PROPOSED TECHNICAL SPECIFICATION CHANGE

SEQUOYAH NUCLEAR PLANT UNITS 1 AND 2

(TVA-SQN-TS-88-12)

DELETION OF ORGANIZATION CHARTS FROM SECTION 6

Figure 6.2-1 Offsite Organization for Facility Management and Technical Support

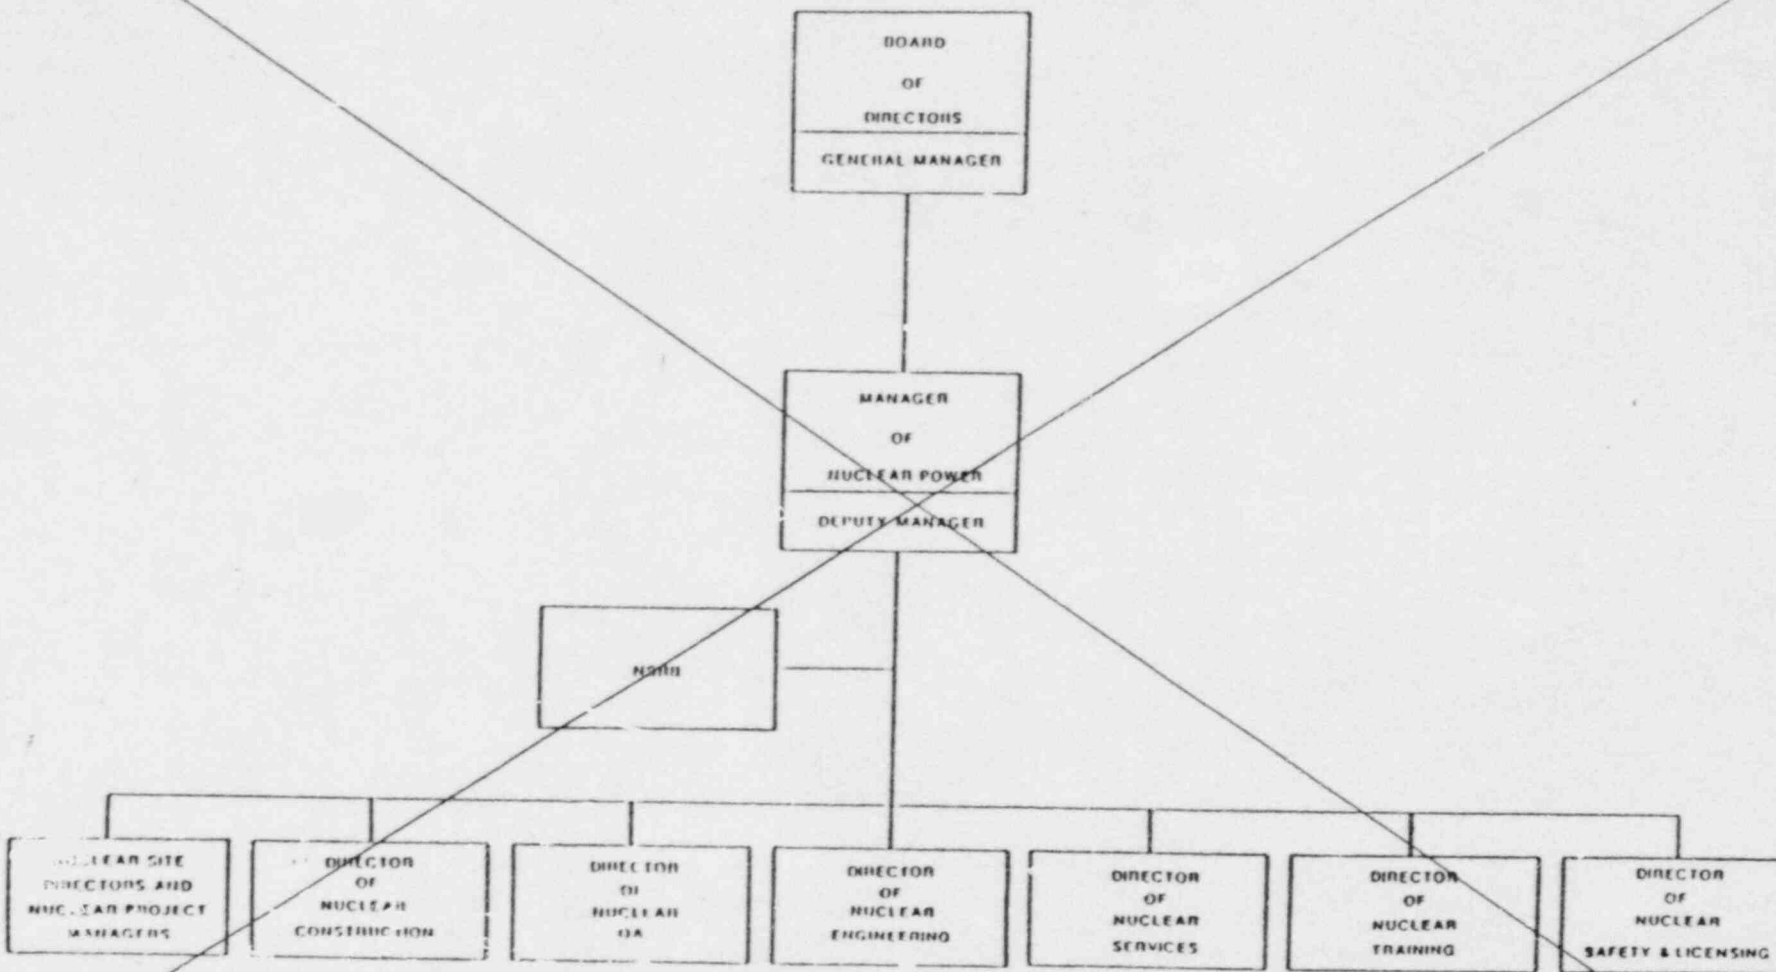
6.2.1 ~~The offsite organization for unit management and technical support shall be as shown in Figure 6.2-1.~~

DELETE
ENTIRE
FIGURE

TVA proposes to modify the SQN units 1 and 2 TSs to delete the organization charts (figures 6.2-1 and 6.2-2) from section 6 in accordance with Generic Letter (GL) 88-06. General requirements for the organizational structure are added to section 6.2. Section 6 is also revised to change the title of the Manager of Nuclear Power and to change the references to the unit staff and organization.

FIGURE 6.2-2

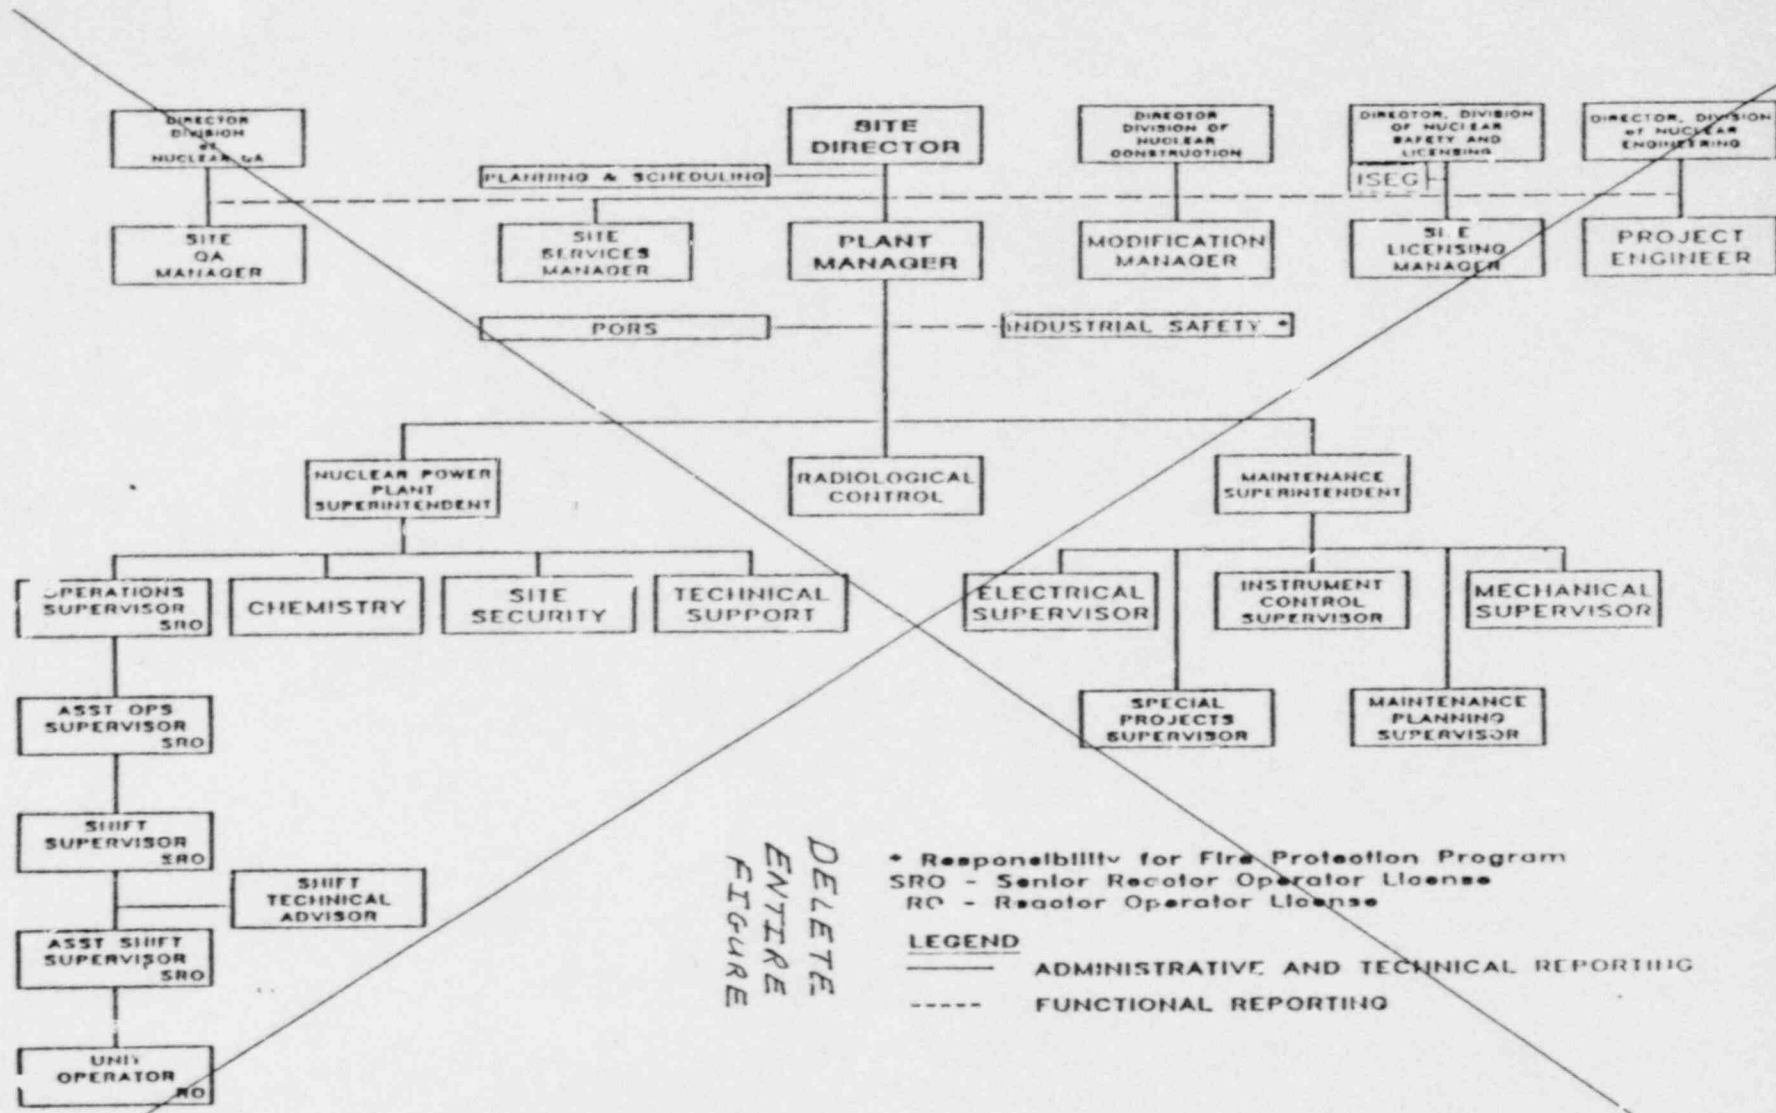
6.2.2 ~~The Unit organization shall be as shown in Figure 6.2-2 and:~~

DELETE
ENTIRE
FIGURE

FIGURE 6.2-1 OFFISTE ORGANIZATION FOR FACILITY MANAGEMENT AND TECHNICAL SUPPORT

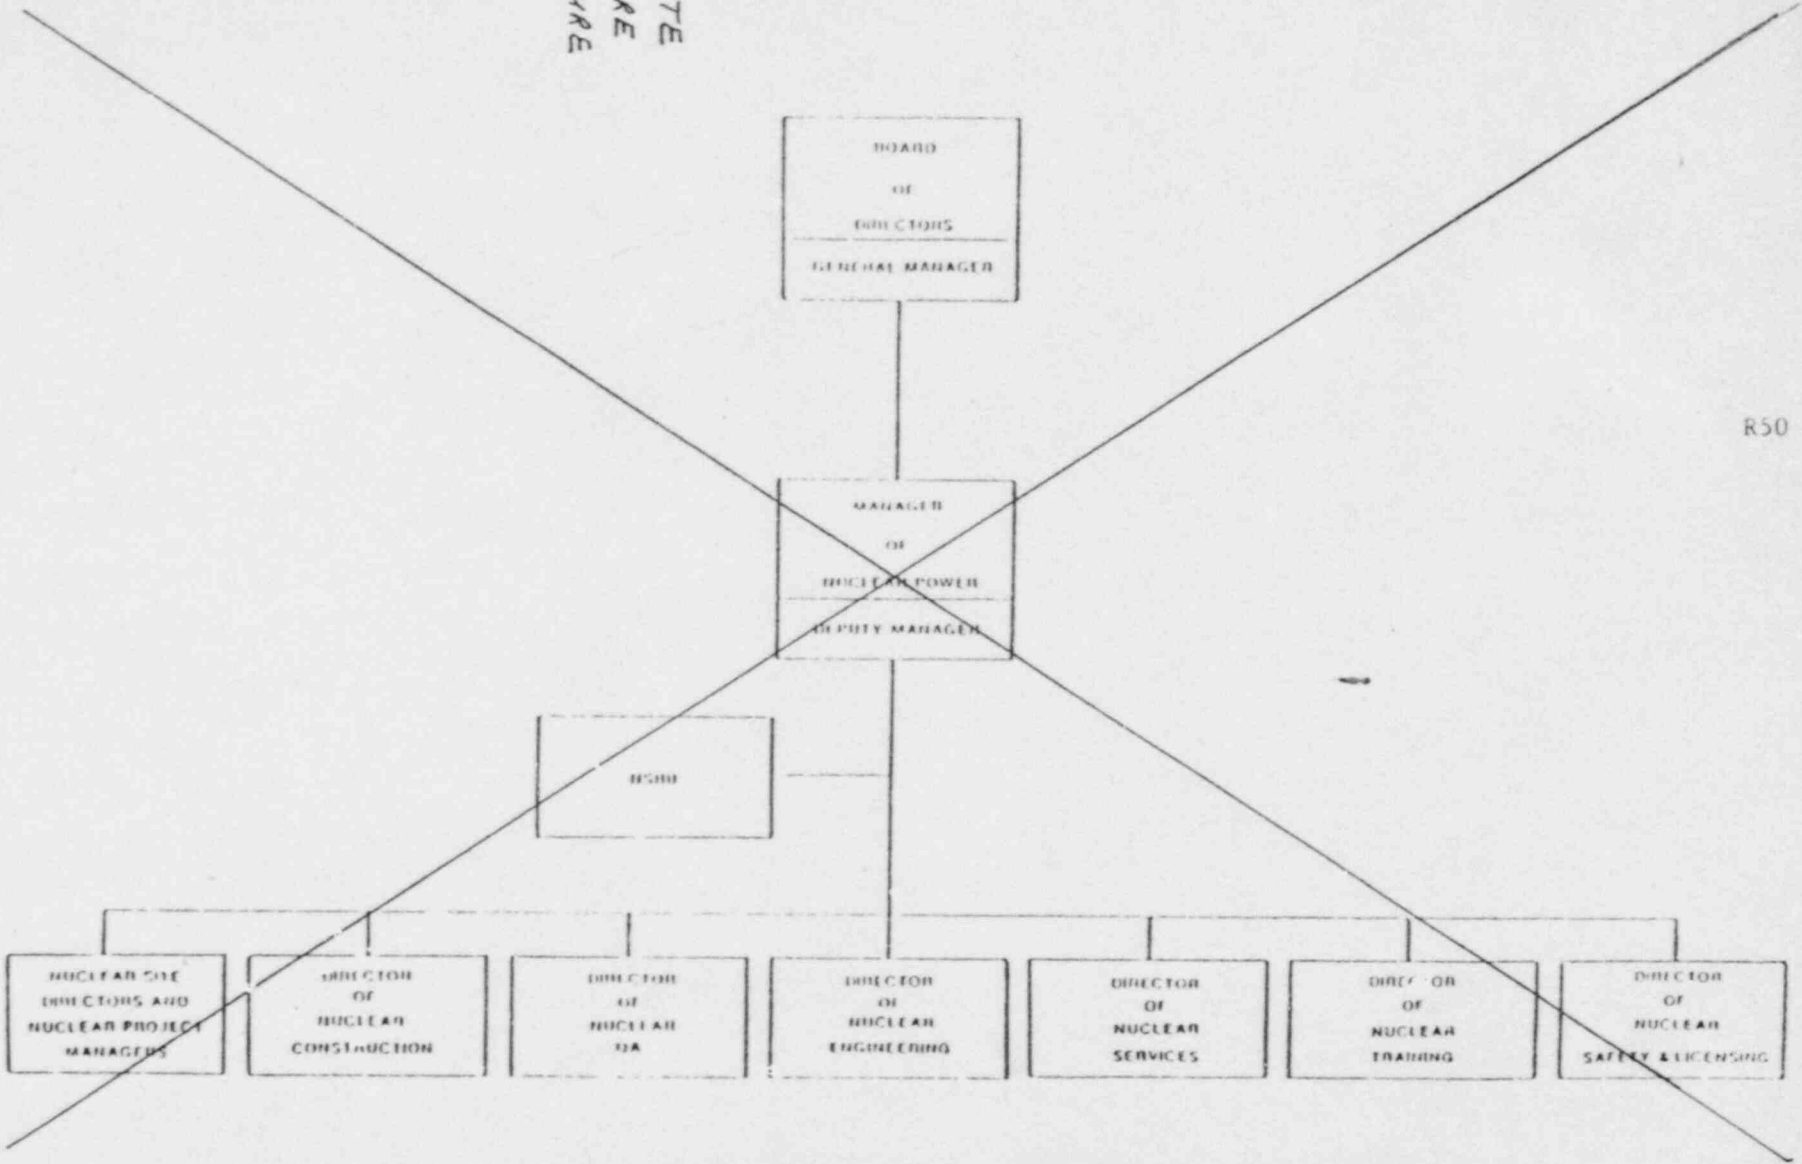
6.2.1 ~~The offsite organization for unit management and technical support shall be as shown on Figure 6.2-1.~~

DELETE
ENTIRE
FIGURE

FIGURE 6.2-2
FACILITY ORGANIZATION - SEQUOYAH NUCLEAR PLANT

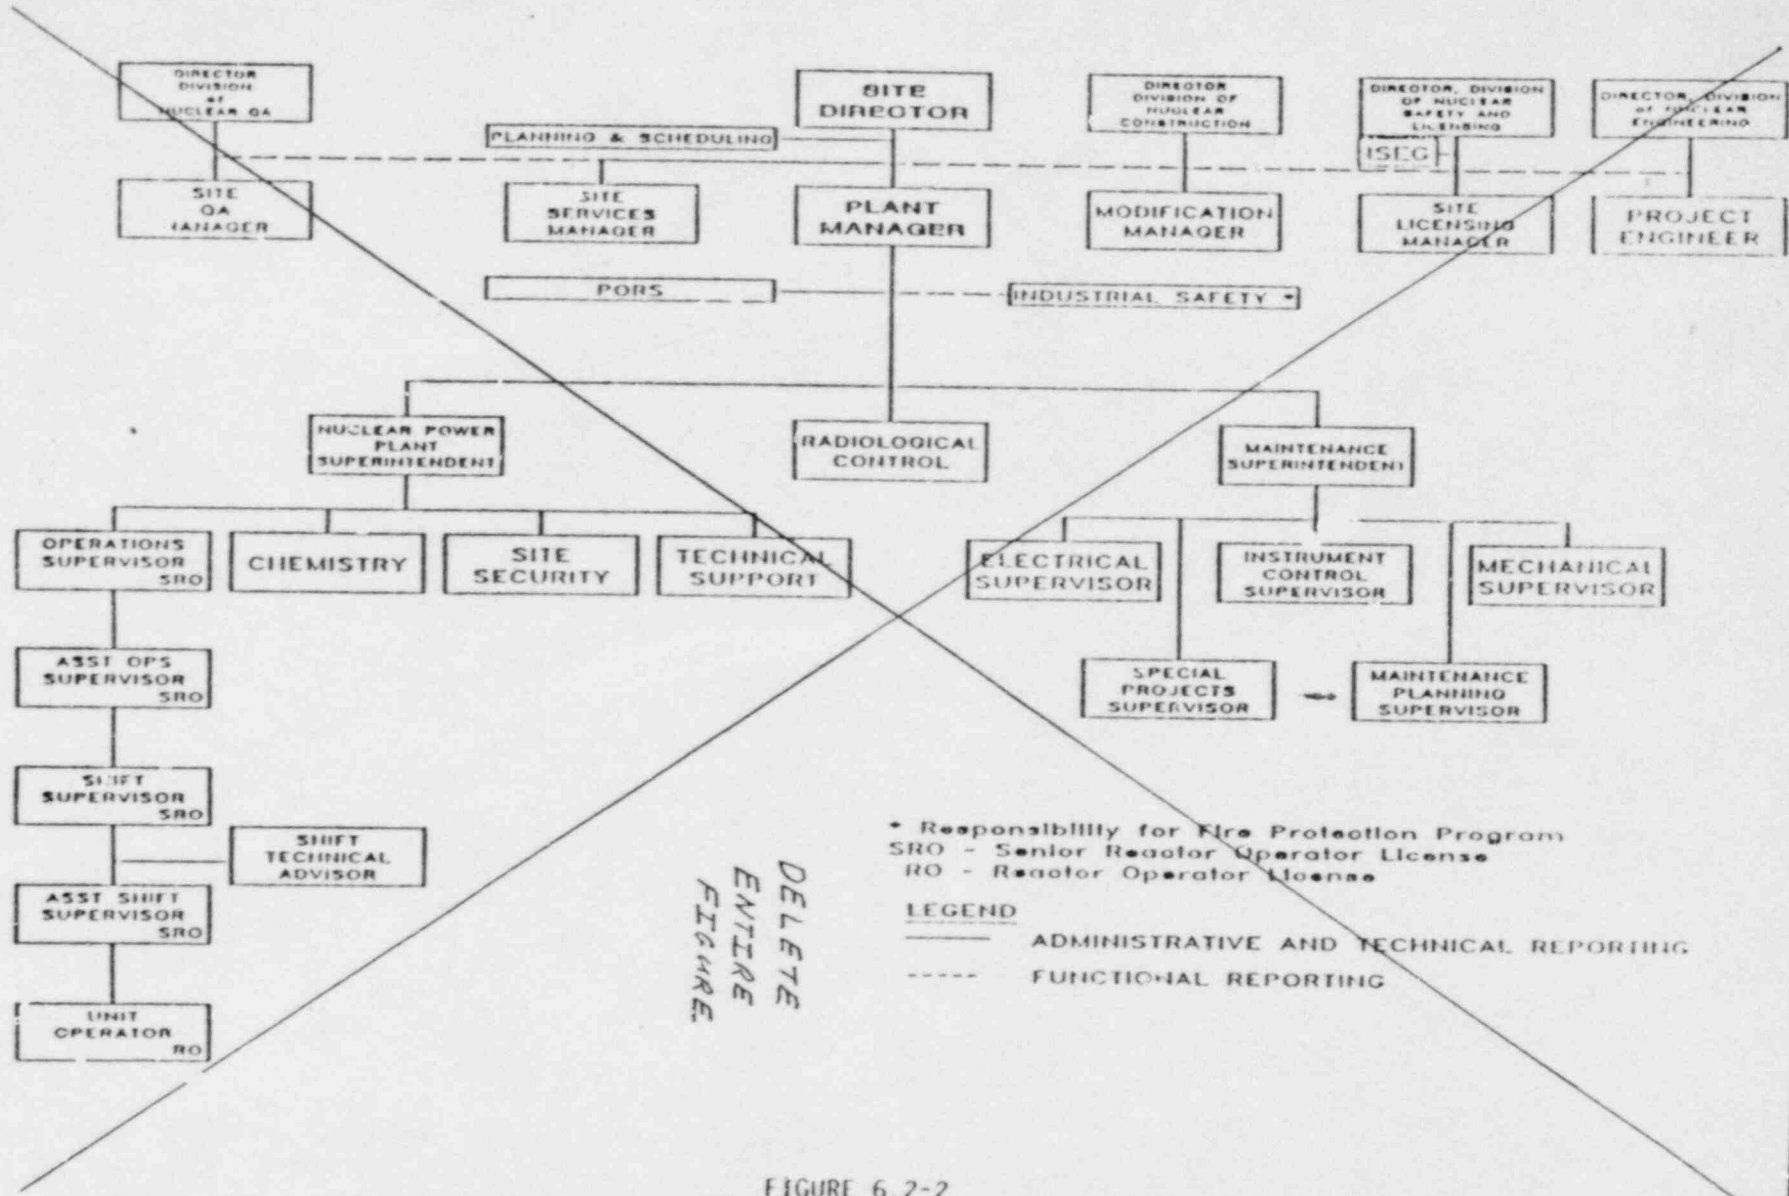
6.2.2 ~~The Unit organization shall be as shown on Figure 6.2-2 and:~~
